Access Compliance Report

Public Rights-of-Way

(Pedestrian Signals)

Intersection ID: N/A	Main Street:	Cross Street: N/A	Location: N/A
ADA ID: 68BFA015E791	Signal Type: One Push Button-APS	Overall Compliance: No	Severity Score: BTN 1: N/A BTN 2: N/A No BTN: N/A
Codes/Mitigation Info/Possible Solution		Field Measurements/Component Compliance

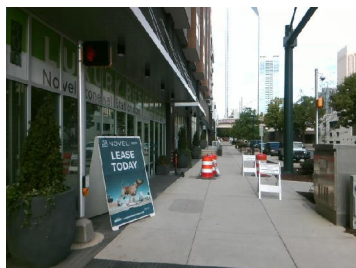
Surveyor Notes: DIST. BETWEEN ADDI. BUTTON IS 416.0IN

PROW/ADA: TMUTCD 4e.08, R404.2, R404.3, R406.2

Possible Solutions: Replace Signal Push Button With APS Button on New Post. Remove & Relocate Sign.
